Formation Design and Build

To: Daniel Boama
From: Matthew Ashley
Date: 25/05/2024
Re: Response to Overheating Compliance and Removal of Brise Soleil

Compliance with Overheating Measures

Please find an abridged table below outlining the main Nonmaterial amendments of the scheme.

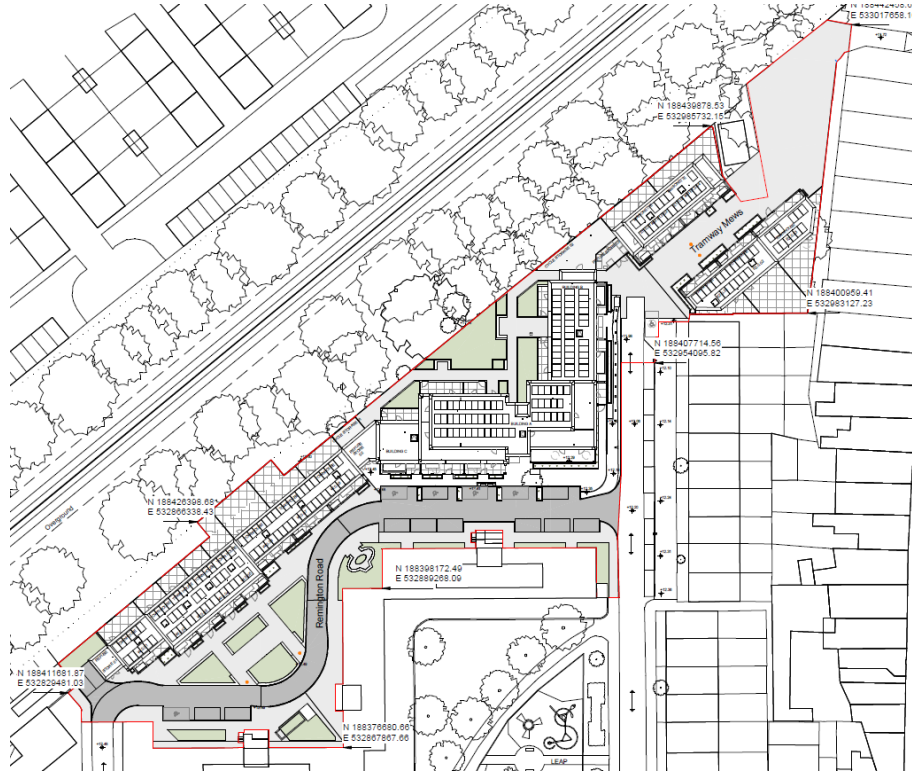
Within the approved NMA from November 2023, the removal of Brise Soleil from the original scheme was minimal and aligns with the goal of optimising the building's design while ensuring compliance. Our comprehensive overheating assessment demonstrates that the revised design, which excludes the Brise Soleil, still meets all necessary mitigation measures.

Figure 2: 3D view of the building – Opening types

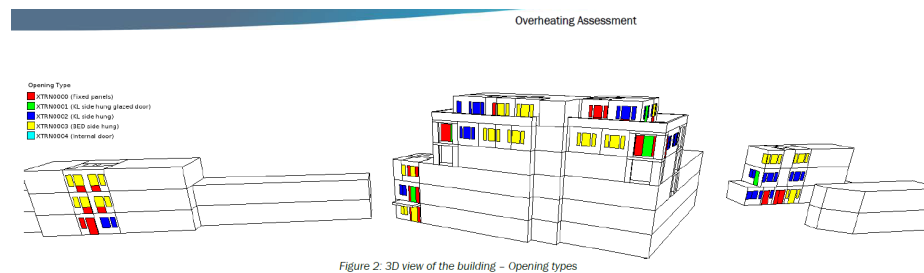
Below are plans indicating which sample dwellings were modelled in the overheating assessment. These samples are representative and validate our compliance with the required standards.
